A417

Missing Link

Report on Public Consultation - Appendices

March 2019

Option 12: an overview

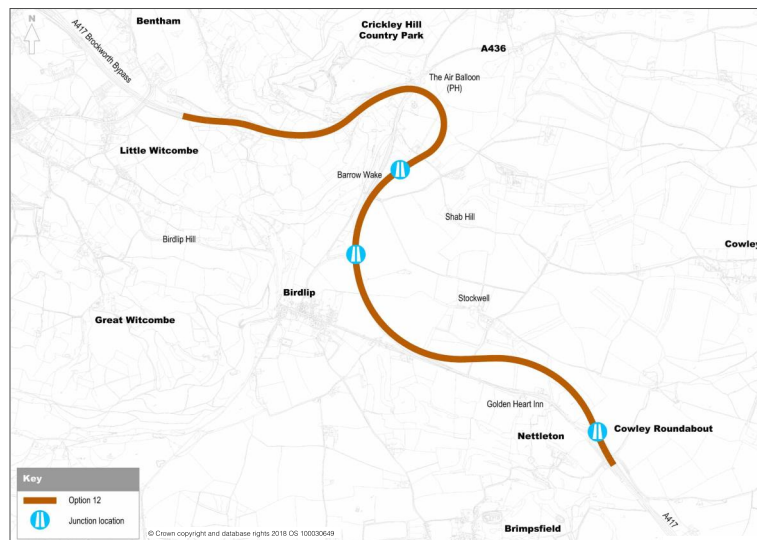
Q2:
Given that Option 12 would require speed restrictions, have a steeper gradients than Option 30 and provide a very low the return on investment it does not appear to be a reasonable alternative to the preferred scheme.

Notes.

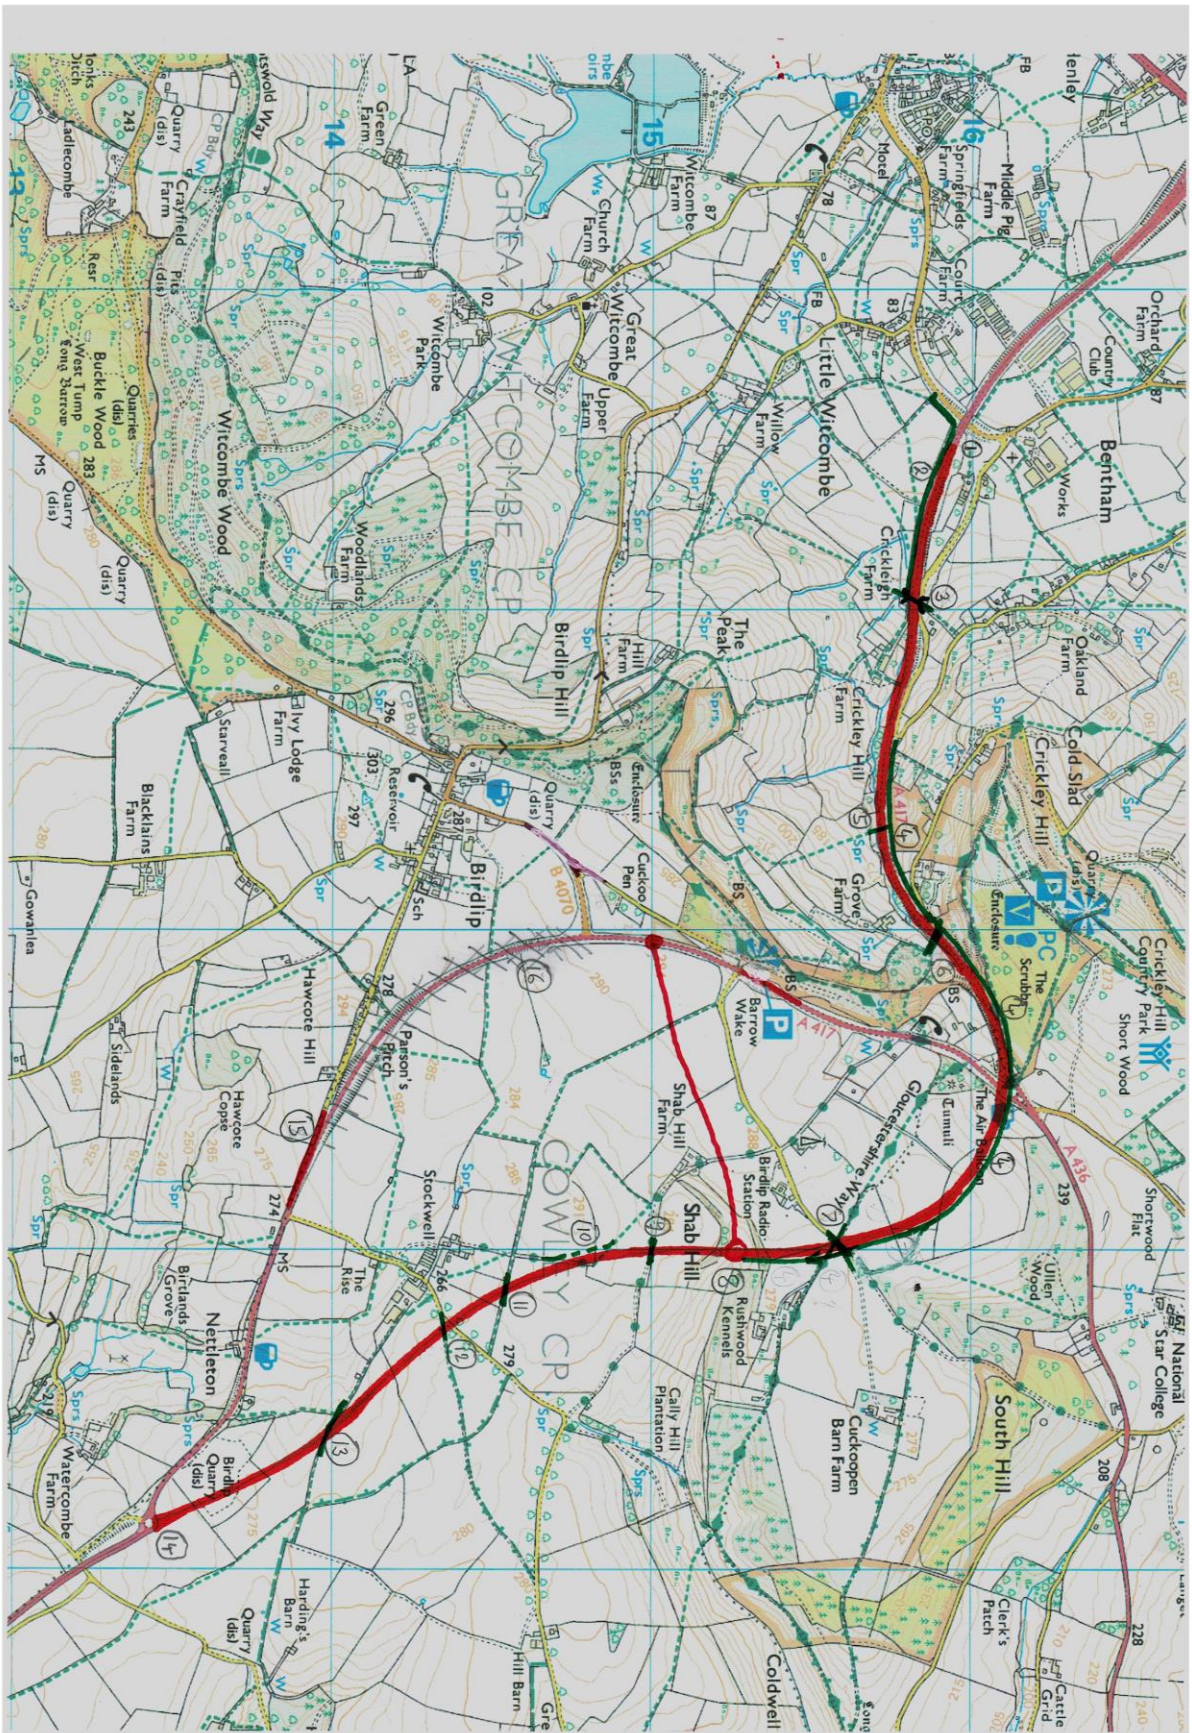
- 1) Start of road link
- 2) Resurface existing public track (PT)
- 3) Grade separated crossing for track and public footpaths (PFs)
- 4) Start of shared use cycle link (also preserving pedestrian connections with Dog Lane, the road to Cold Slad and the PFs currently using the A417 verge locally.
I've shown it on the uphill side – reducing danger from traffic.
Ideally separated from and uphill from A417, with landscaped buffer strip between.
- 5) Crossing for PF
- 6) Crossing for PFs
- 7) Grade separated crossing for PFs, PTs and road (slightly rerouted to all use same crossing)
- 8) Interchange with new A436 link road; cycle track joins with new A436 road link.
- 9) Grade separated crossing for PT
- 10) Re-routed PF (economy – removes the need for crossings)
- 11) Grade separated crossing for PT
- 12) Grade separated crossing for PF & road (slight realignment of PF to suit)

- 13) Crossing for PF
- 14) End of road link, new interchange
- 15) Rerouting of old section of A417 onto Birdlip Road
- 16) Redundant section of A417 removed
- 17) Rationalise/straighten road access from new road link to Birdlip

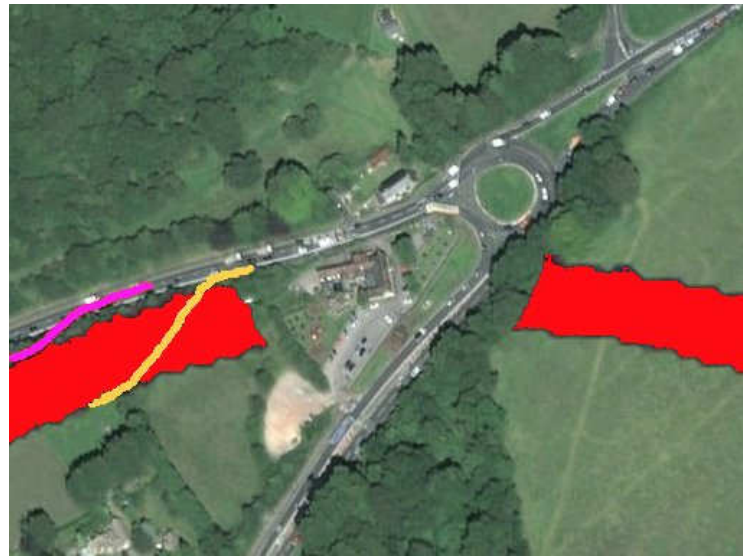
1. cuts the new A417 slightly below surface to reduce traffic noise, with level bridges over for footpath etc
2. deletes the cross link to save the countryside and money & includes slips onto the new A417 at the Air Balloon
3. has a green bridge (short tunnel) below the pub and retains the Cotswold and Gloucestershire Ways on their present lines

It should meet many of the requirements for the road and surely ought to be worth subjecting to a costing analysis. However it's realised there may be further benefit in adjusting the length of the tunnel and/or its location.

If it's accepted that the opening Option 30 is only an initial line of a route, ramblers should be able to work with Highways England and other bodies in evolving it and other proposals. However it's necessary to reject the two Options put forward at this stage of the consultation, in the way they're presented.

Simplified Option 30

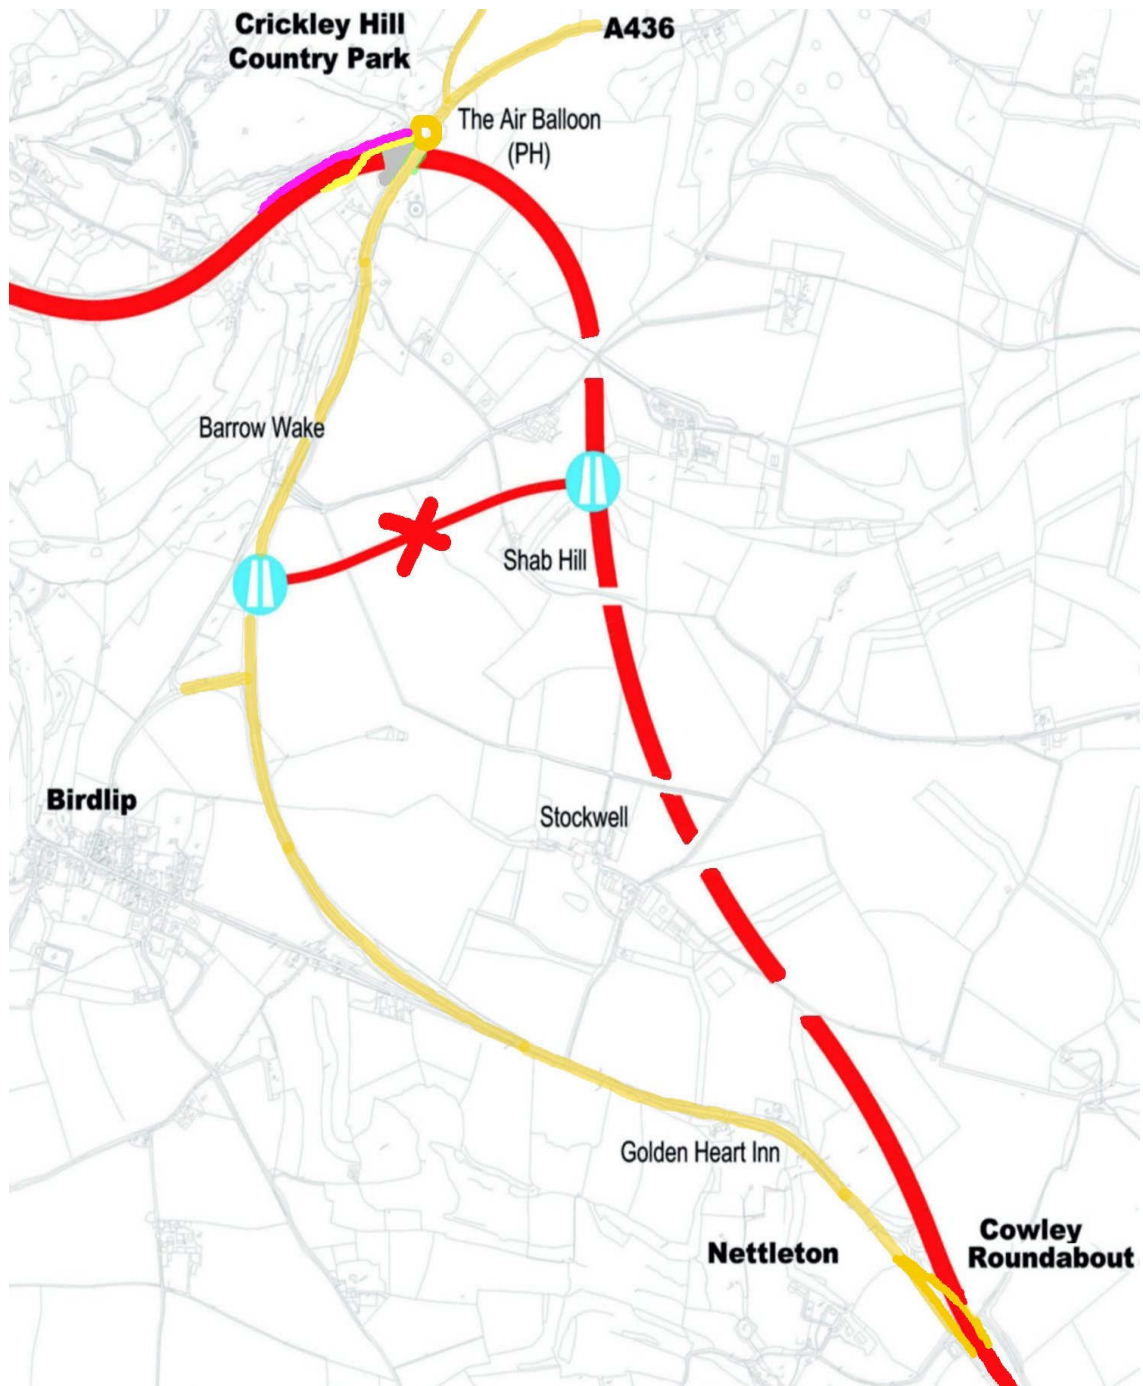
Note A436 access to new A417
(same as Option 3 tunnel arrangement)
